**From:** HANSON, Jerud <jeh@nei.org>  
**Sent:** Monday, March 12, 2018 1:54 PM  
**To:** Benner, Eric; Govan, Tekia  
**Cc:** REMER, Jason; HANSON, Jerud  
**Subject:** [External\_Sender] Industry Feedback for March 14th RIS Public Meeting  
**Attachments:** NEI Members Comment Worksheet - March 2018 RIS Version 3-12-2018.xlsx; ML18051A084 - RIS 2017-XX - With Line Numbers.pdf; RIS Operating Experience Section Suggested Rewrite.pdf; Table 2 Suggested Revision.pdf

**INDUSTRY COMMENTS TO MARCH 2018 DRAFT RIS 17-XX SUPPLEMENT-1 TO RIS 2002-22**

9 **DRAFT NRC REGULATORY ISSUE SUMMARY 2002-22, SUPPLEMENT 1**  
10 **CLARIFICATION ON ENDORSEMENT OF NUCLEAR ENERGY INSTITUTE GUIDANCE**  
11 **IN DESIGNING DIGITAL UPGRADES IN INSTRUMENTATION AND CONTROL SYSTEMS**  
12

**Figure 1 – EXAMPLE ENGINEERING EVALUATION PROCESS**

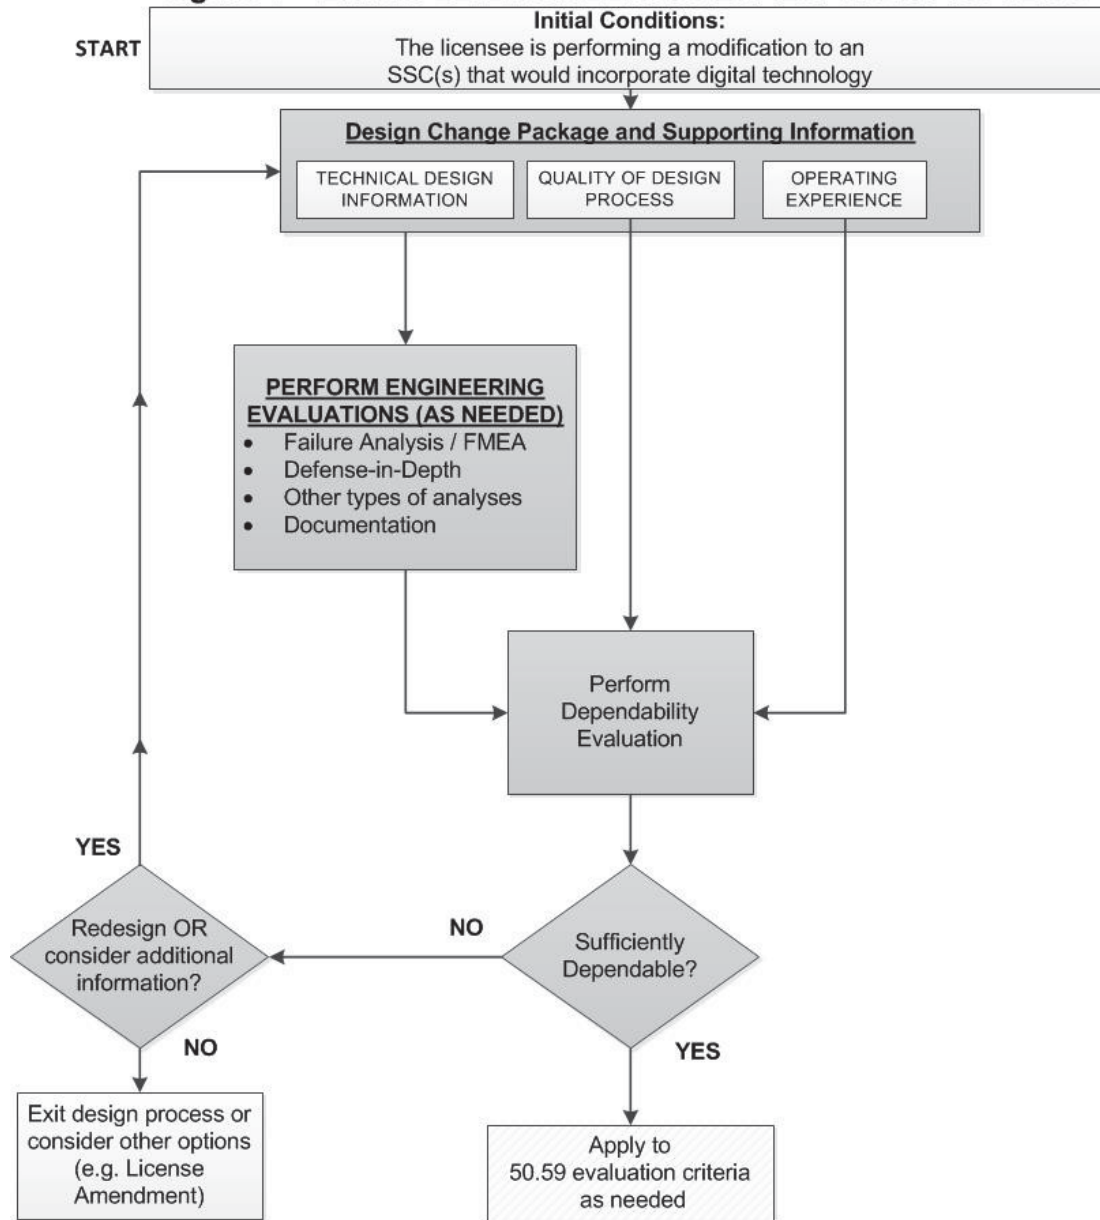
LINE NO.	PAGE NO.	PRIORITY	INDUSTRY COMMENT	RECOMMENDED CHANGE	ADDITIONAL COMMENTS	ACTION TAKEN
807	14 of 17	1	Consider deleting Figure 1. This figure leads a licensee to believe that only a Dependability Evaluation is needed. Licensees would prefer to have the RIS provide guidance strictly on Qualitative Assessments for determining equipment/SSC reliability, and then using the Qualitative Assessment to support arguments made in the 50.59 Evaluation.			
810	15 of 17	1	Table 2 - See industry version of Table 2.			
NA	NA	1	This document provides a lot of guidance on I&C design, in particular, for non-safety related systems. In some cases, the requirements go beyond what is required by the operational quality assurance program used by licensees, and design and licensing bases requirements for non-safety related systems. The RIS should focus on the licensing aspects, not the design aspects of digital upgrades.	Remove design requirements from the RIS. Inclusion of design attributes is useful, and should remain.	Licensees know how to design - they have very detailed and proceduralized guidance along with a quality assurance program. NRC and licensees have not been aligned on adequate documentation of design considerations. The new RIS is supposed to provide licensees with acceptable methods for documenting qualitative assessments for relaying their design thought process in a way that an inspector can understand pertinent design considerations.
